# SERVICE BULLETIN

M-1050

## FLT Ultra MODEL HEADSET SPEAKER NOISE

Figure 1. Main Chassis Ground Stackup

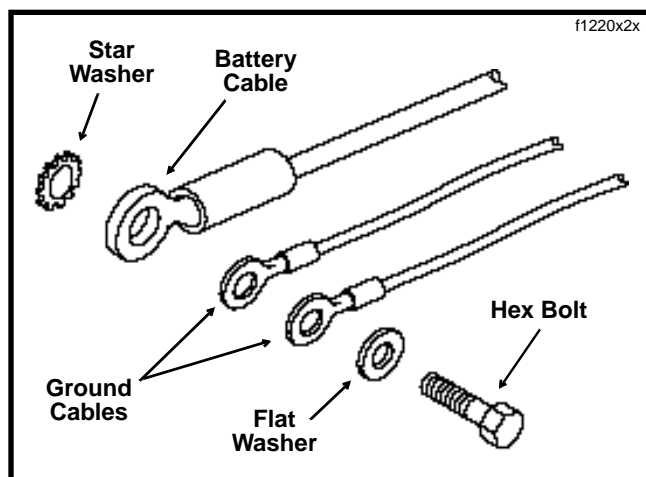
If headset static is encountered on FLT Ultra models outside of the specified build range, check the ground connections between the radio, fork, frame and main chassis ground. Main chassis ground stackup on frame cross member in front of battery should be star washer, battery cable, ground cables, flat washer and then hex bolt. See Figure 1. Also verify that the fuel tank bolts are tight.

Figure 2. 7-Place DIN Connector (Under Seat Location)

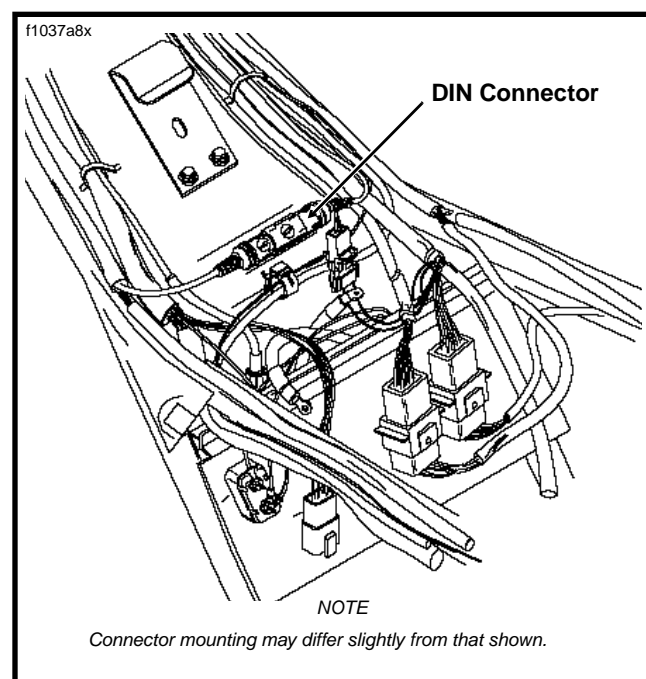
If headset static is encountered on a 1995 FLTC-U, FLHTC-U or FLHTCU-I model manufactured and shipped from the York, Pennsylvania Assembly plant between November 17, 1994 and January 27, 1995 (**VIN numbers SY507383 to SY601652**), replace the DIN cable (Part No. 76292-95) as the first step in troubleshooting the problem. See DIN Cable Replacement below.

2. Separate pin and socket halves of DIN connector in under seat location. See Figure 2.
3. Cut cable straps to release DIN cable from frame, wire harness conduit and wire bundles on right side of vehicle.
4. Remove clamp to release DIN cable from forward area of frame.

1. Connect **new** DIN cable at fairing location. Route free end of cable back to the under seat area following the original path. Connect DIN cable connector at under seat location.
2. **FLHTC-U/FLHTCU-I Only:** Capture wire harness conduit, wire bundles, antenna cable and DIN cable in clamp at inner fairing location. Secure clamp (and ring terminal of ground wire) to upper fork bracket.
3. Capture wire harness conduit, wire bundles, antenna cable and DIN cable in clamp on right side of vehicle. Secure clamp (and ring terminal of ground wire) to forward area of frame.
4. Secure DIN cable to wire harness conduit, wire bundles and frame using **new** cable straps. Cut any excess cable strap material.
5. **FLHTC-U/FLHTCU-I:** Install the five screws (with flat washers) to secure the retaining ring and headlamp assembly to the fairing. Install the headlamp door.

**Figure 3. 7-Place DIN Connector (Fairing Location)**

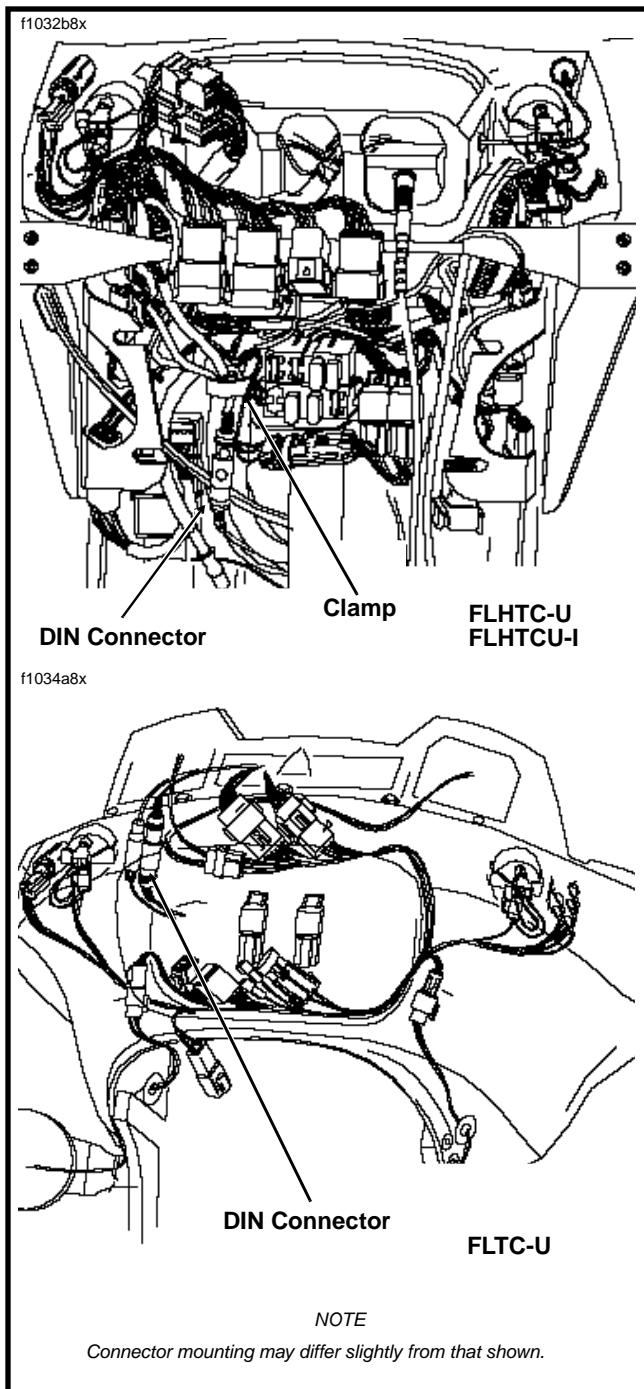
5. **FLHTC-U/FLHTCU-I:** Remove the screw to release the headlamp door. Remove the five retaining ring screws (with flat washers) and gently pull the retaining ring and headlamp assembly from the fairing. See Figure 3. Reaching in through the opening in the fairing, remove the clamp to release DIN cable from upper fork bracket. Cut cable strap, if present.

6. Separate pin and socket halves of DIN connector at fairing location. Remove DIN cable from vehicle.
